**Comments to the Environmental Protection Agency on
“Accounting Framework for Biogenic CO₂ Emissions from Stationary Sources”
(September 2011)**

Comments Submitted: October 18, 2011

A comparison of burning sustainably produced biomass versus natural gas to produce electricity

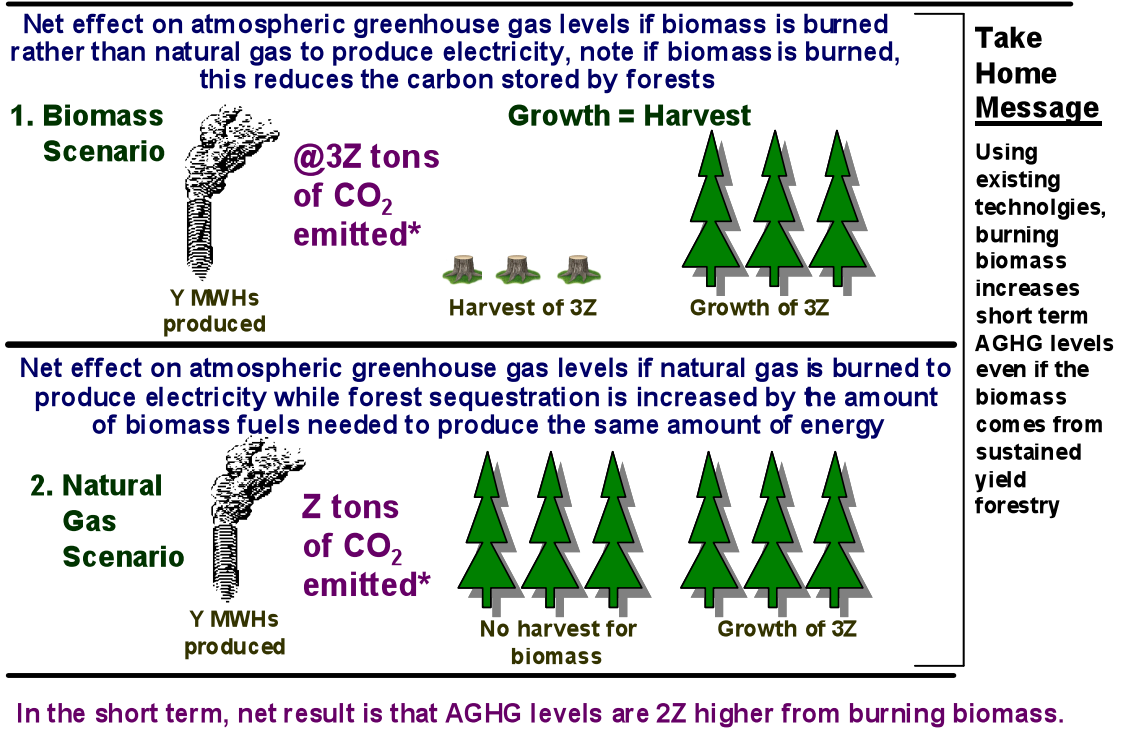
Under the second accounting approach (“Case Study 2”),⁷ bioenergy production is allowed to claim credit for a portion of the gross forest growth. Stated simply, the rule set forth in the proposal is that bioenergy can claim credit for gross forest growth in proportion to the share of total harvests in a region that result from bioenergy. For example, if gross forest growth within a region absorbs 80 tons of carbon each year, and traditional forestry removes 90 tons, the region’s forests are already losing 10 tons of carbon each year. Even so, if bioenergy removes another 10 tons, those 10 tons will still be considered 80% carbon free under EPA’s approach. Why? Because bioenergy would then remove 10% of the overall forest products (10 of 100 tons), and, according to the framework, would be entitled to claim credit for 10% of the 80 tons of carbon accumulated by gross forest growth each year. Ten percent of 80 tons equals 8 tons, so 8 of the 10 tons of carbon used and emitted by bioenergy would be considered carbon-free, making the biomass 80% carbon-free.

It is worth noting that neither of the approaches described by EPA in Case Studies 1 and 2 requires that the harvested forest be allowed to re-grow. Under either approach, bioenergy would still be considered completely or nearly carbon free even if the trees were harvested while converting the forest to a parking lot.

More to the point, the fundamental flaw in both cases is that the forest growth on which EPA relies to conclude that bioenergy production is completely or largely carbon-free would occur anyway. A basic rule of logic and science is that the effect of an action must be judged against the baseline, and that baseline must reflect what would occur without that action. Since in each of these examples the forest carbon accumulation would be occurring anyway, bioenergy cannot take credit for it. The following graphic illustrates this basic problem by showing how the use of biomass to displace natural gas for electricity production can result in higher atmospheric GHG levels, even when the biomass comes from a forest where harvest does not exceed growth. As shown in the graphic, biomass-based power production emits approximately three times as much CO₂ as natural gas-based power production on a tons-of-CO₂-per-MW basis. A tripling in the amount of CO₂ emitted per megawatt generated will unavoidably increase atmospheric CO₂ levels, *unless* the forest’s sequestration capacity also triples. EPA’s “Accounting Framework” does not require any increase in sequestration capacity, however. Under EPA’s proposed approach, a source can fully discount its CO₂ emissions as long as harvest does not exceed growth in the given region.
